**BOARD OF COMMISSIONERS OF THE PORT OF NEW ORLEANS**  
**NOTE TO PERSPECTIVE BIDDERS**  
**CONTRACT FOR**  
**HARMONY STREET WHARF**  
**ROOF REPLACEMENT**  
**DAMAGED BY HURRICANE KATRINA**

July 2, 2009

ADDENDUM NO. 1

**UPSTREAM WALL ELEVATION—IMPROVEMENTS**

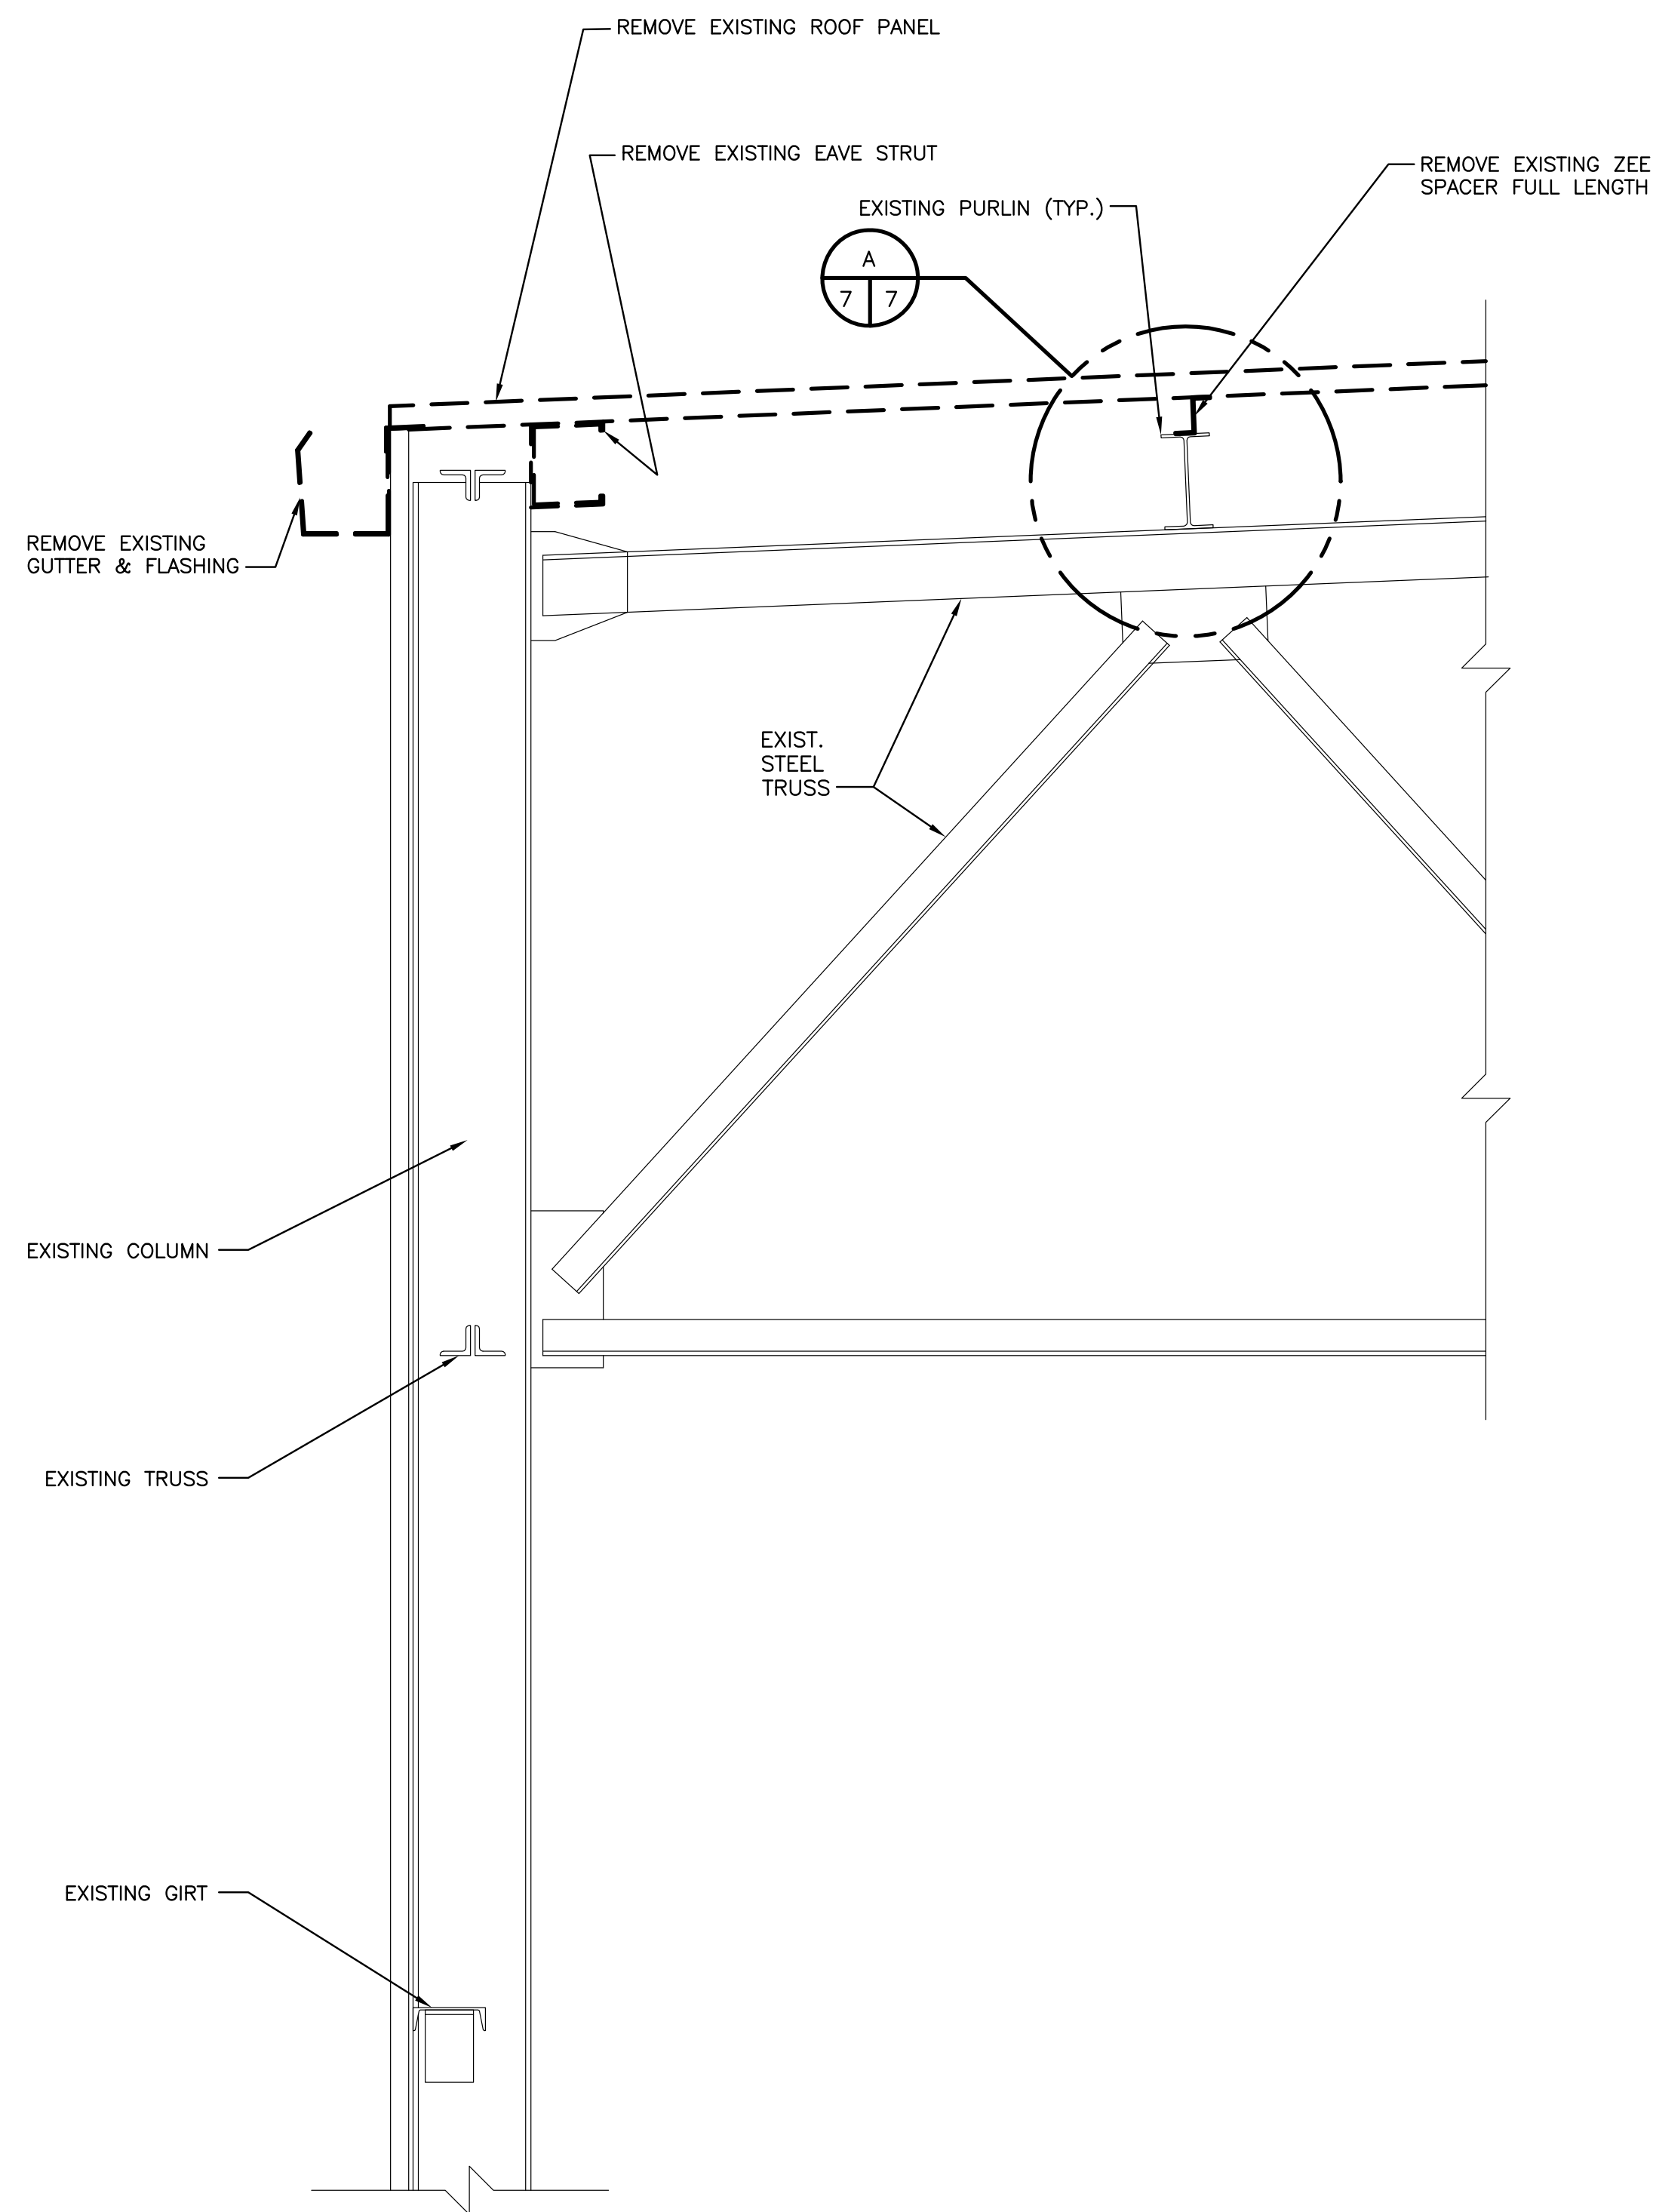
- Q: The plans only show 2 elevations (north, south, no west), the south elevation has existing translucent panels (partial south & partial west), the plans show installing new panels could you clarify?

- A: Drawing 6A addresses the west elevation and is included as part of this addendum.
- Q: Plans and specs have no dimensions for the cowls, please clarify.
